SERVICE PARTS LIST FOR MITSUBISHI ELECTRIC PACKAGED AIR-CONDITIONERS

Series : PEFY-P•VMHS-E

BWE1104E

Please change the old catalog (issued July 2019, No.BWE1104D) to this new catalog.
Content of revision : Some of parts are changed.

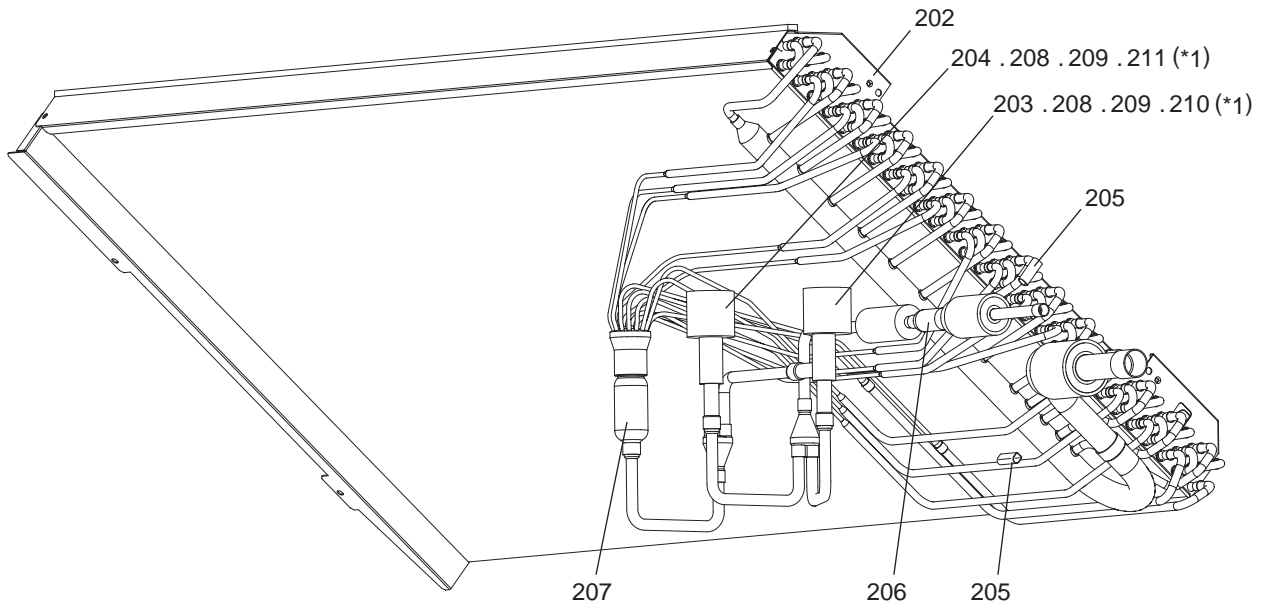
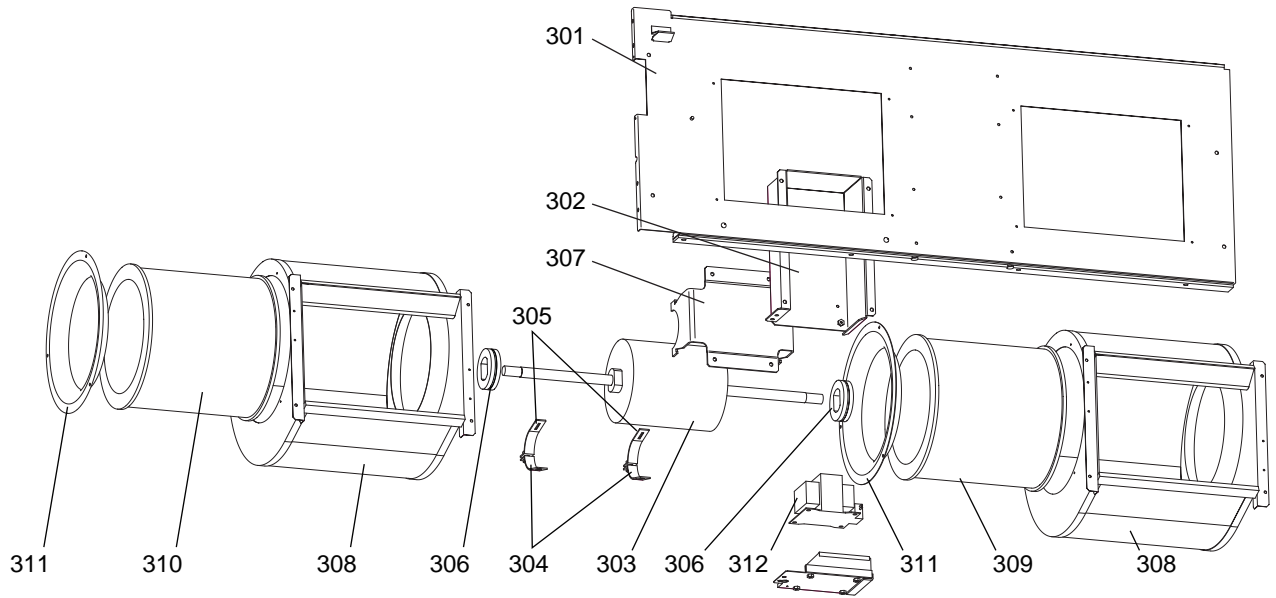
*1 Products manufactured to Sep. 2019 use EFM type LEV,
and products after Oct. 2019 use PAM type LEV.
In case of EFM type LEV is used, please change to PAM type LEV.
In that case, replace it with a set of 203, 204, 208, and 209.
Please order 210 and 211 when replacing only the motor part with EFM type.

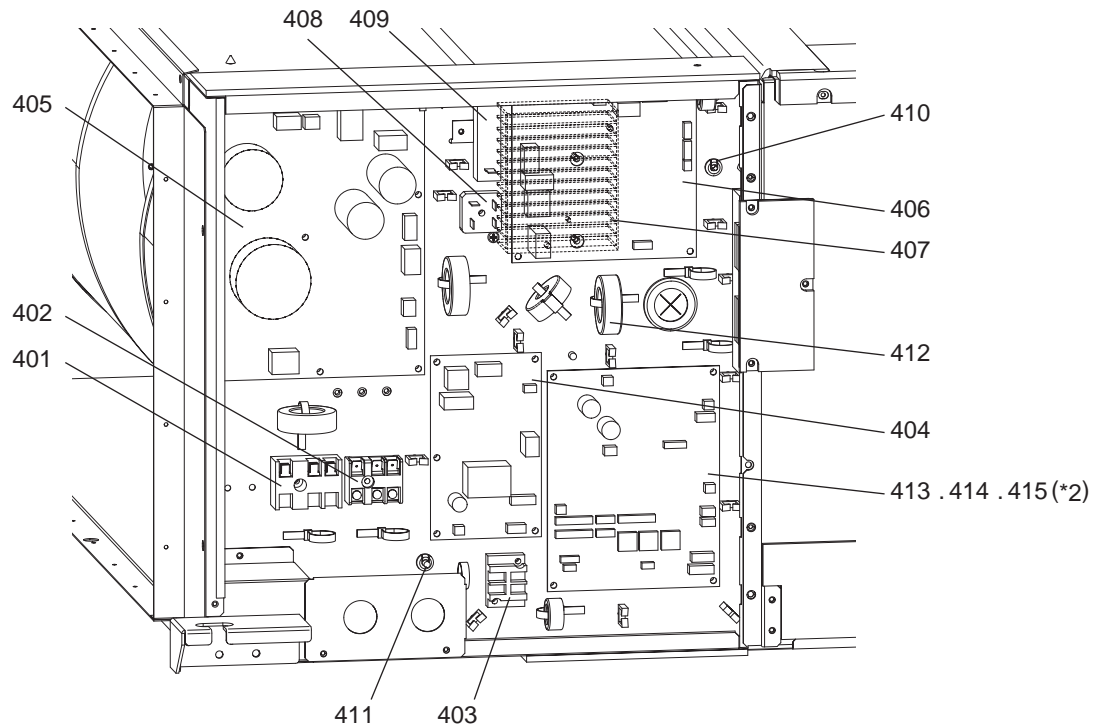
*2 For the products whose serial number is 5XW**** or later, be sure to use No.415.
For the products whose serial number is from 2ZW**** to 59W****, be sure to use No.414 or No.415.
For the products whose serial number is 2YW**** or earlier, No.413, No.414 or No.415 can be used.
If the production number of the indoor unit is not available, procure parts No.415.
No.413 or No.414 will be supplied as long as the stock is available,
and only No.415 will be supplied after the existing stock of No.413 or No.414 is depleted.

~2YW****	2ZW****~59W****	5XW****~
No.413	USE	NOT USE	NOT USE
No.414	USE	USE	NOT USE
No.415	USE	USE	USE
